ASI #047.1

Project: 1910.00 INC 2 - Tennyson HS Bldgs. A, B, C, D, P, S, G, M, O
27035 Whitman Street
Hayward, California 94544
Phone: 510-723-3190
DSA File #: 1-H6
DSA Application #: 01-119941

Gym Court Striping & Basketball Backboards

ISSUE DATE: 09/26/2024

A-G2.2

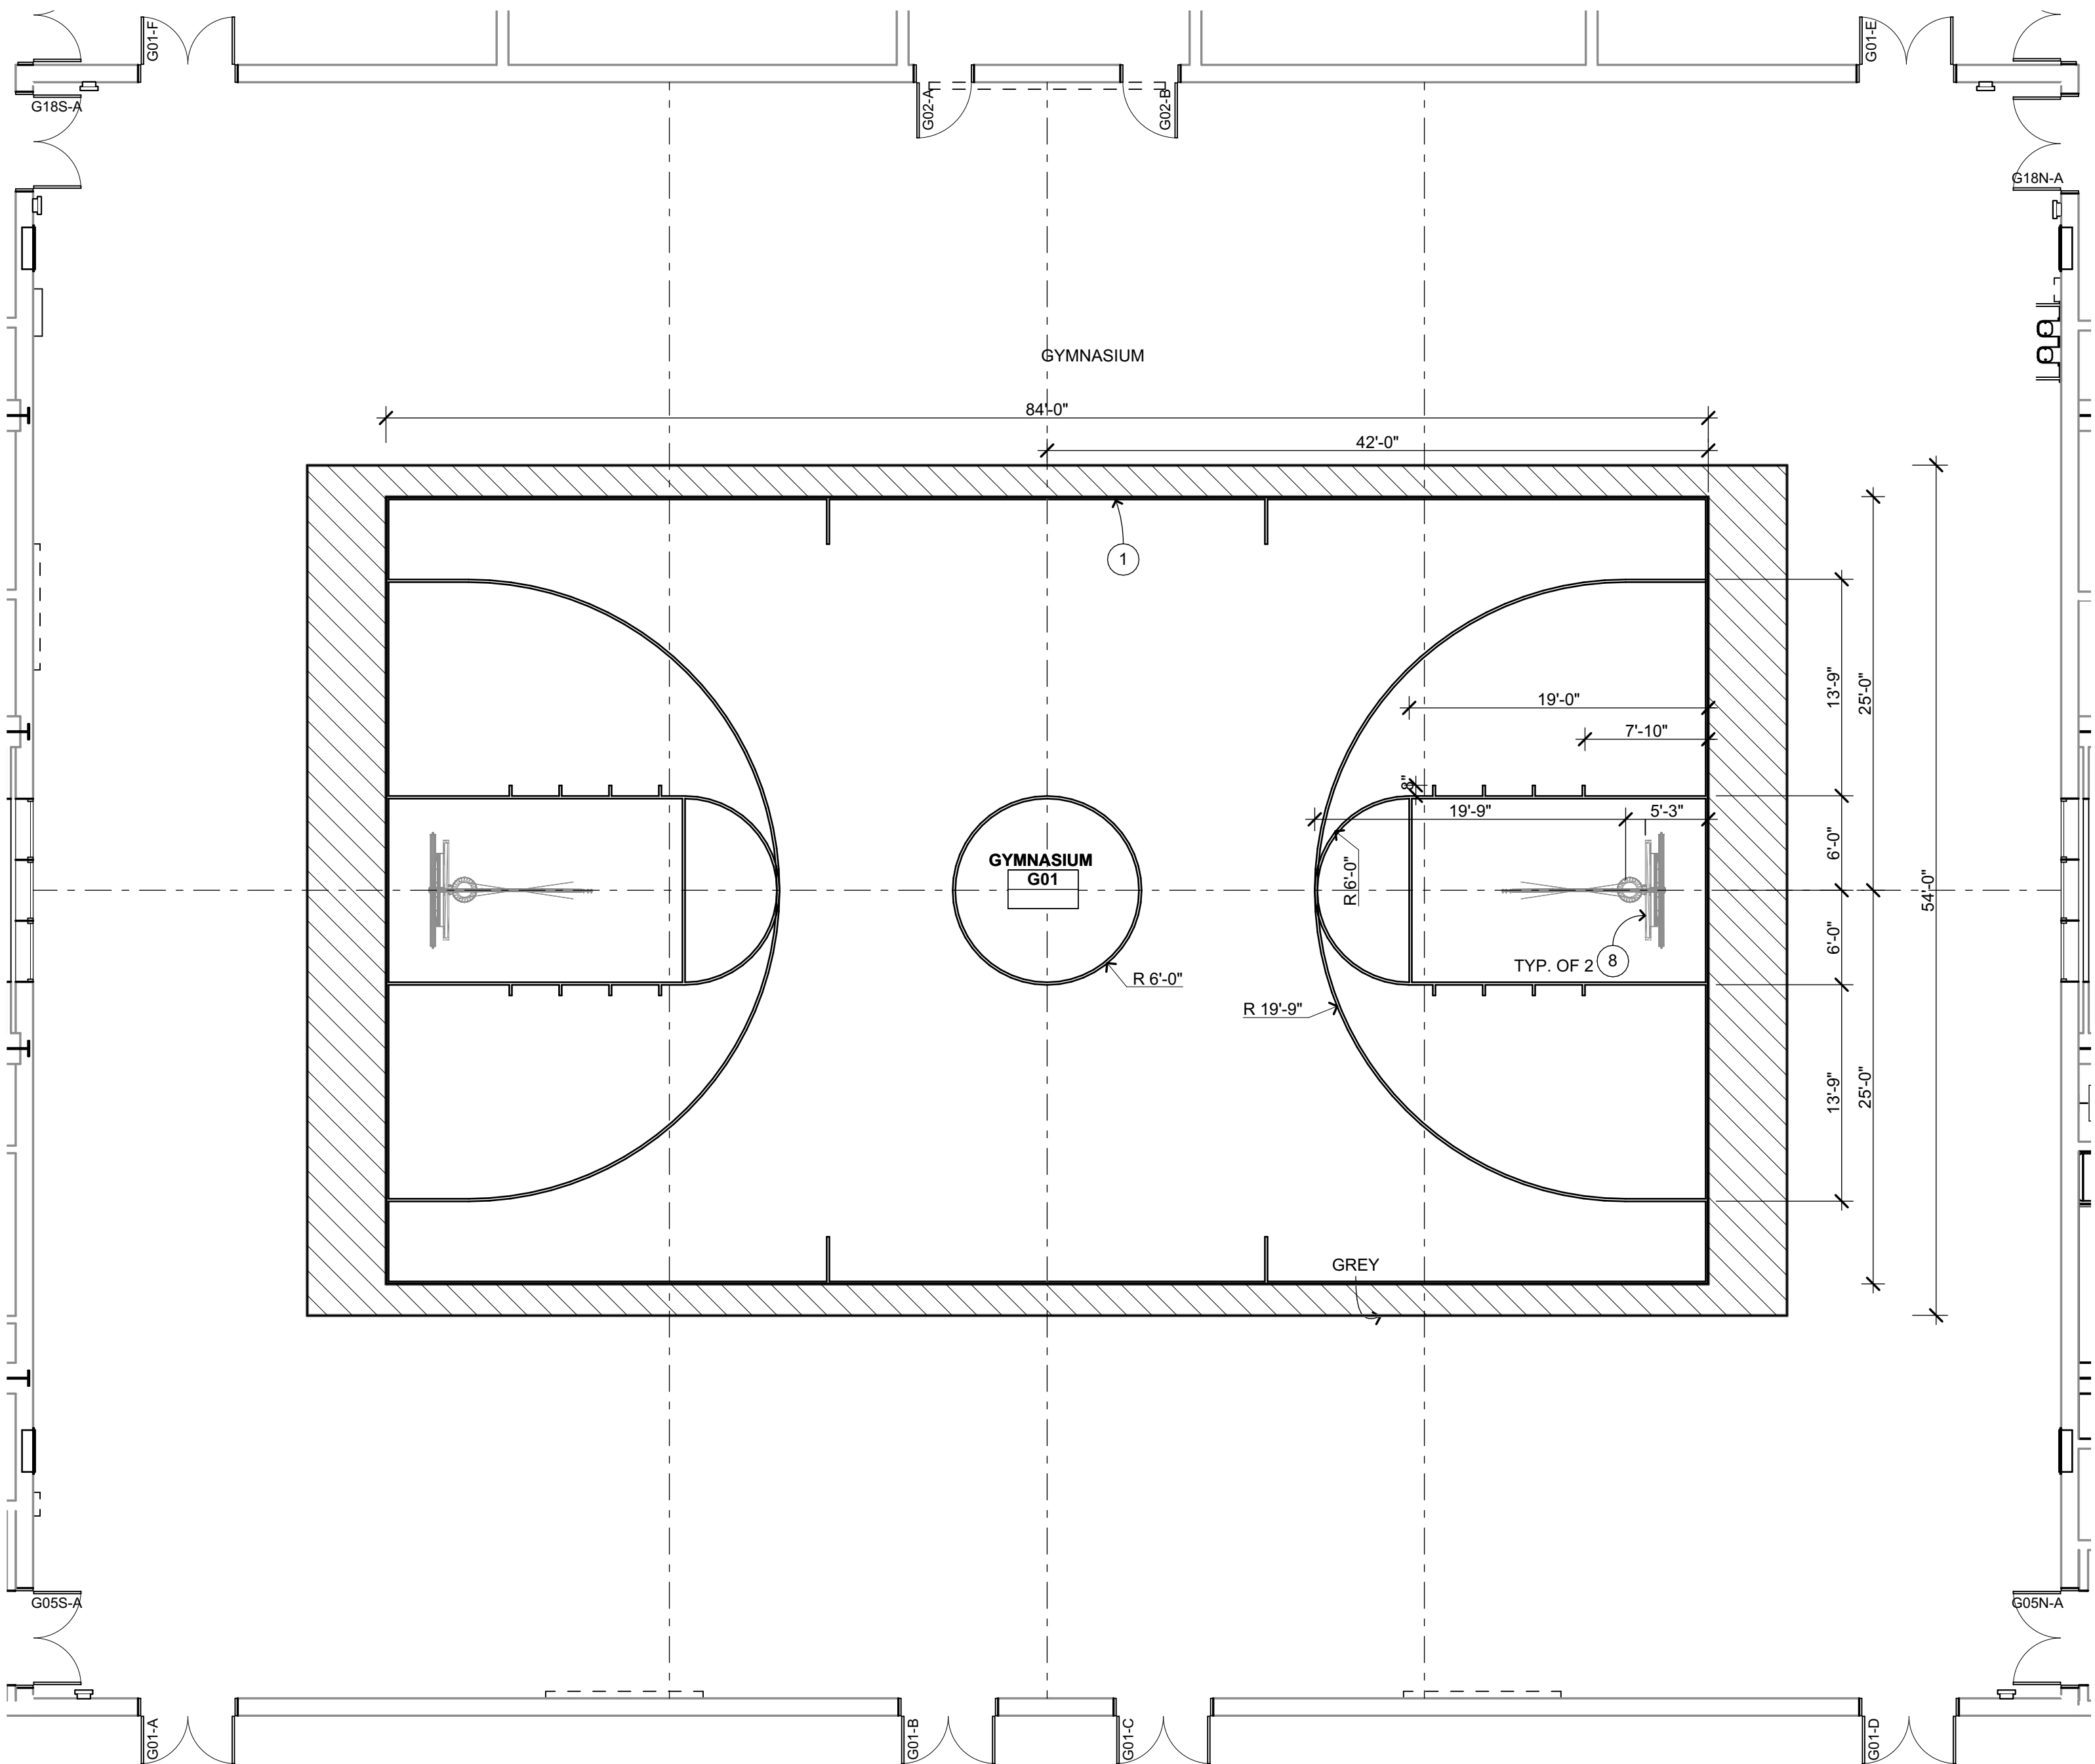
Only changes involved court striping on sheets:

A-G2.2 and A-G2.4.
